FERNIE SKATEPARK REDEVELOPMENT WORKSHOP #2 DESIGN DIRECTION REPORT

FALL 2022 - PHASE 2 OF ENGAGEMENT

FERNIE SKATEPARK REDEVELOPMENT DESIGN DIRECTION REPORT

In-Person Workshop & Online Survey #2

Design Direction Feedback

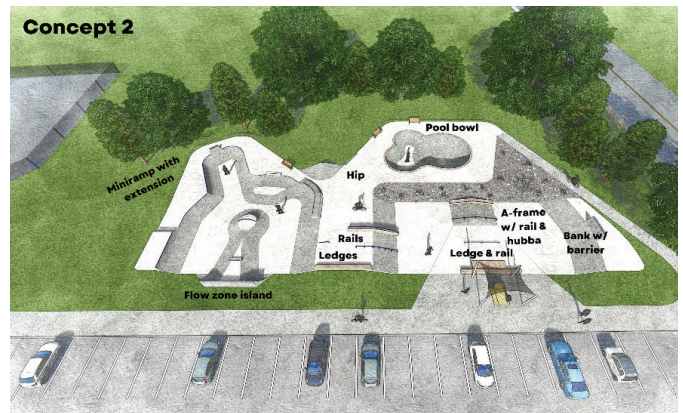
Community preferences at the consultant-facilitated in person workshop were a near-even split between Concept Direction 1 and 2, while online survey responses indicated a greater interest in Concept Direction 2. Overall, Concept Option 2 received the highest number of votes as the preferred general stylistic direction.

When factoring in qualitative descriptive comments, there was a strong public desire to explore incorporating the bowl from Concept 1 within the Concept 2 Direction. In addition, respondents noted that despite transition and obstacle style terrain being the most requested style of features, attention to other elements (ie. plaza/'real street') should not be overlooked to create a well-rounded park for the community (ie. consider moderating the amount of transition terrain in Concept Option 2). For whatever configuration of final design, respondents also highlighted the need for adequate spacing between features and attention to rider staging areas.
